APPLICATION NO.	FILING DATE	FIRST NAMED INVENTOR	ATTORNEY DOCKET NO.	CONFIRMATION NO.
09/893,524	06/29/2001	Paul D. Perry	51481-5069	2982

Office Action Summary

DETAILED ACTION

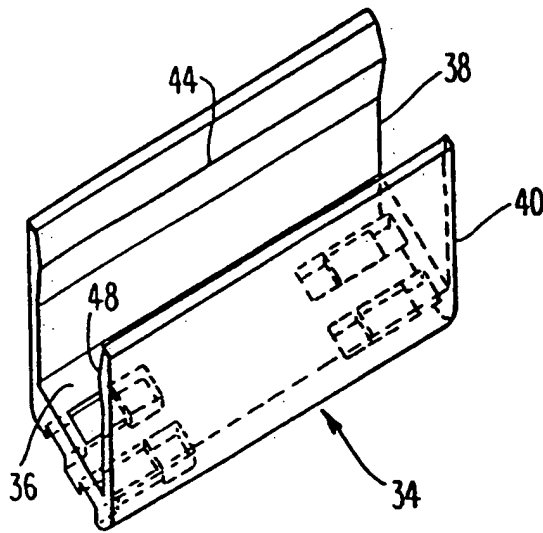
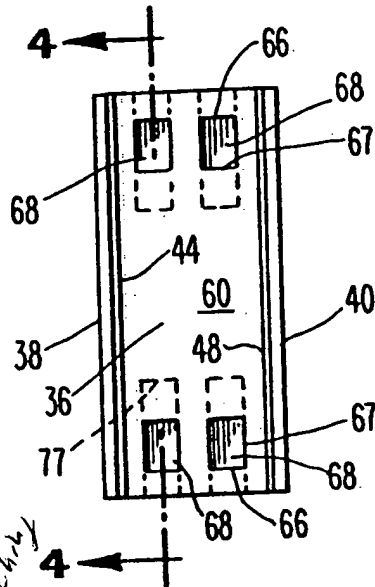
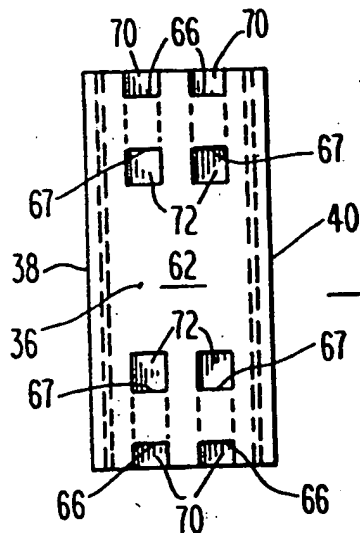
Claims 1-4 and 14-18 are rejected under 35 U.S.C. 102(b) as being anticipated by Mason et al. ("Mason"). Mason discloses a mount 30 for an electrical device 12 including a body and a plurality of electric contacts 18, the body having a base and at least one lateral face extending from the base, and the plurality of electric contacts projecting a first distance from the base (see attachment), the mount comprising: an electric terminal 32 including a solder portion (see attachment) being adapted to be soldered to at least one of the plurality of electric contacts; and a platform (the portions of transverse portion 36 sandwiched between the terminal and the base) adapted for spacing at a second distance the base from the solder portion electric terminal, the second distance being substantially equal to the first distance (see attachment).

portion having a second cross-section transverse with respect to the axis, the second cross-section being smaller than the first cross-section (see attachment).

Per claim 4, the first and second cross-sections are generally rectangular, the first portion comprises a first width transverse with respect to the axis and a first height transverse with respect to the axis and perpendicular to the first width, and the second portion comprises a second width transverse with respect to the axis and a second height transverse with respect to the axis and perpendicular to the second width, and the second height is less than the first height (see attachment).

Fig. 5

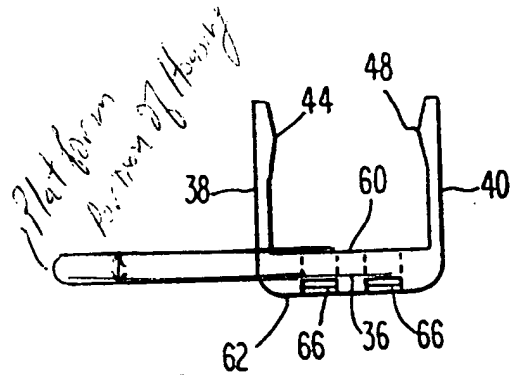
Per claim 3, the platform is adapted to be contiguously sandwiched between the base and the second portion.

Platform portion sandwiching terminal

Fig. 4

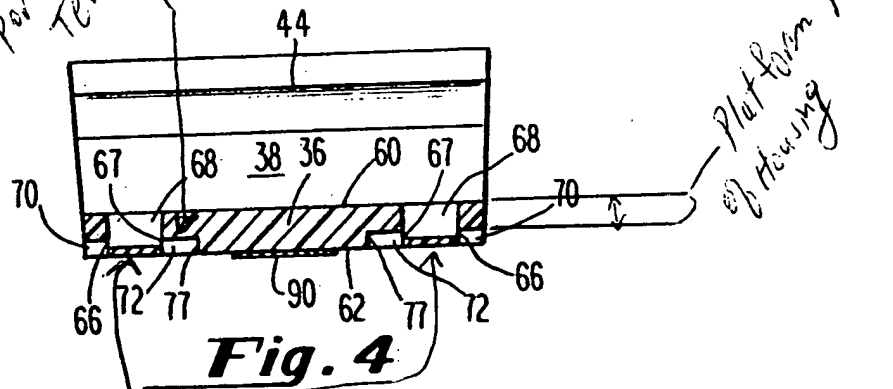
Per claim 14, the mount further comprises a housing supporting the terminal such that the terminal is contiguously sandwiched between the housing and the platform (see attachment).

Housing portion sandwiching terminal
